| • **DRIVEABILITY—DIAGNOSTIC TROUBLE CODES (DTC) P0500, P1502 AND/OR U1039 CONTINENTAL MODELS ONLY—STICKING OR BINDING IGNITION LOCK CYLINDER—HIGH EFFORT WHEN TURNING IGNITION SWITCH**<br>• **ELECTRICAL—STICKING OR BINDING IGNITION LOCK CYLINDER—HIGH EFFORT WHEN TURNING IGNITION SWITCH** | **Article No. 01-21-13** |

**FORD:** 1998-2002 CROWN VICTORIA, MUSTANG, TAURUS
1998-1999 F-250 LD
1998-2001 EXPLORER
1998-2002 E SERIES, EXPEDITION, F-150, RANGER, WINDSTAR
1999-2002 SUPER DUTY F SERIES
2000-2002 EXCURSION, EXPLORER SPORT
2001-2002 EXPLORER SPORT TRAC

Figure 1 - Article 01-21-13

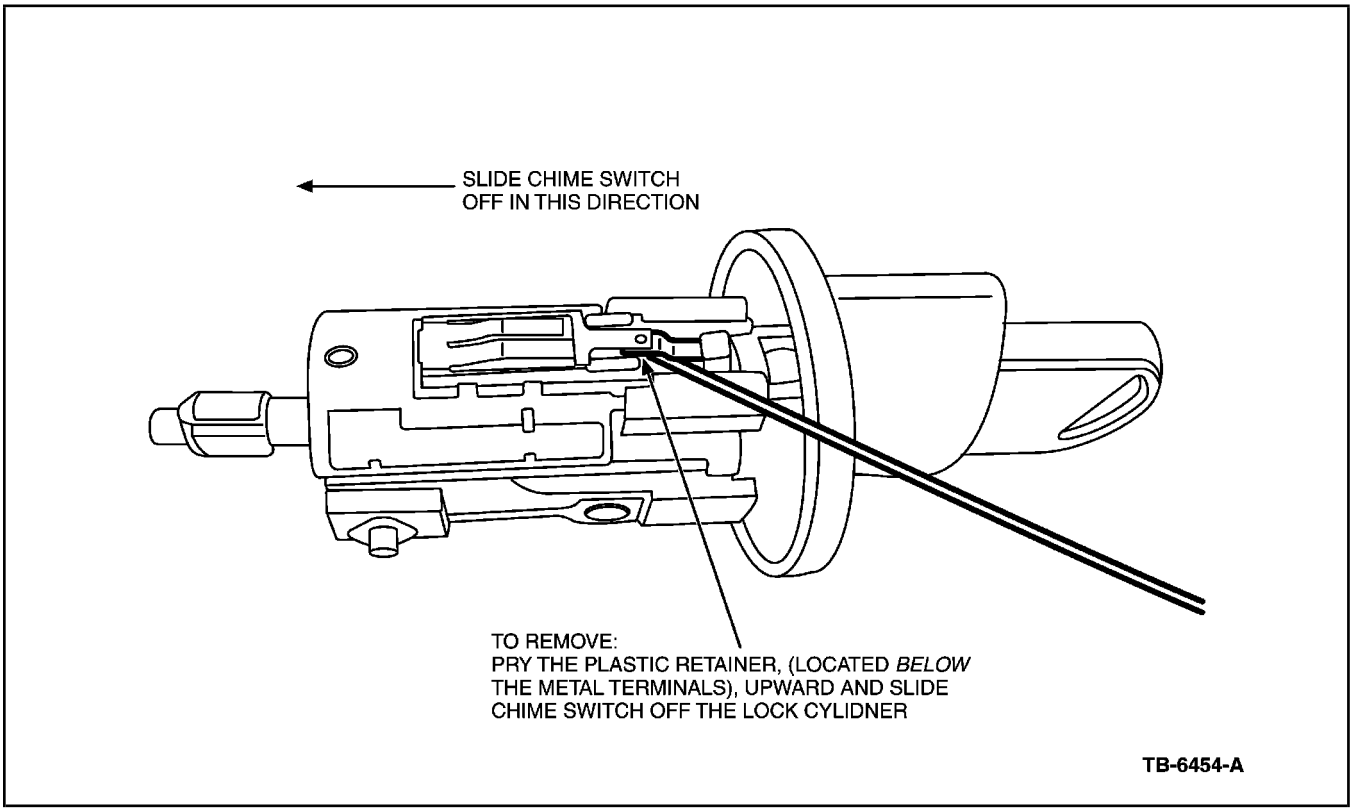
4. Remove the Plastic Key chime warning switch by prying upward on the plastic retainer, while sliding the switch away from the key insertion end (Figure1). Refer to the appropriate model Workshop Manual, Key-in-ignition warning switch removal and installation section located in Section 413 if additional detail is required.

5. Install a new Key-In-Ignition warning chime switch XL2Z-11A127-AB and reinstall lock cylinder.
6. Verify proper function of the Ignition Switch Lock Cylinder and Key-In-Ignition warning chime switch.
